18th December 2023

23/P/01850|Hybrid planning application comprising: A full planning application for the demolition and retention of existing buildings and erection of new buildings to provide extra care housing (Use Class C2) and associated ancillary accommodation and amenity space, public realm works, atgrade car parking, plus restoration and upgrade works to Braboeuf Manor (ancillary accommodation and amenity space) and the refurbishment of Pound Cottage (Use Class C3); and An outline planning application for a residential led scheme (Use Class C3) and car park, with all matters reserved except access | The University Of Law Braboeuf Manor, Portsmouth Road, Guildford, GU3 1HA

Deliversity of Law, Portsmooth Road Guildroft - Accurate Visual Representations

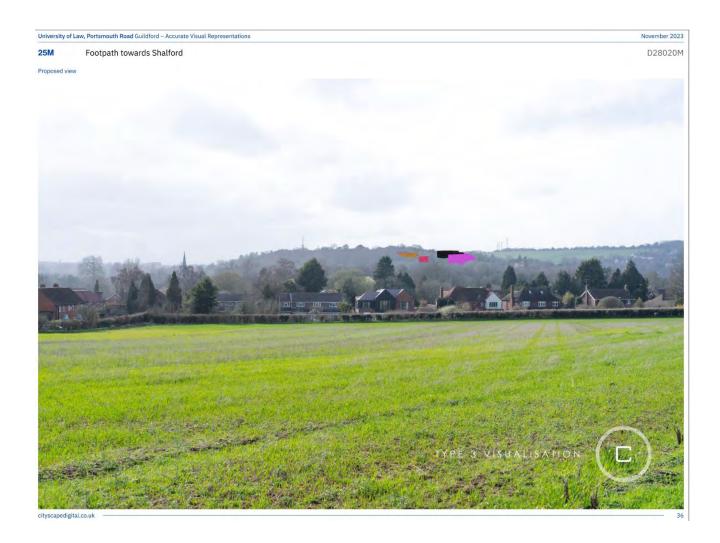
This illustration shows the impact of the development which can be easily seen through various gaps in the built environment as one goes up this particular road. It is notable that the building on the left in the illustration is a heritage building, part of the St Catherines conservation area, and the scale of the proposed buildings don't fit well with the character of the area even though they are at a distance within this view.

It is also noted that by moving the camera across the road to the other side of the road it is likely that the buildings proposed for the Law College would be far more visible. This again shows the requirement to have a proper modelling tool such as the VU.City to fully show what the impact is. It is also noted that the wireline illustration with the purple building on the right-hand side shows this building breaking the skyline which we believe is against the idea of protected views for the sensitive area.
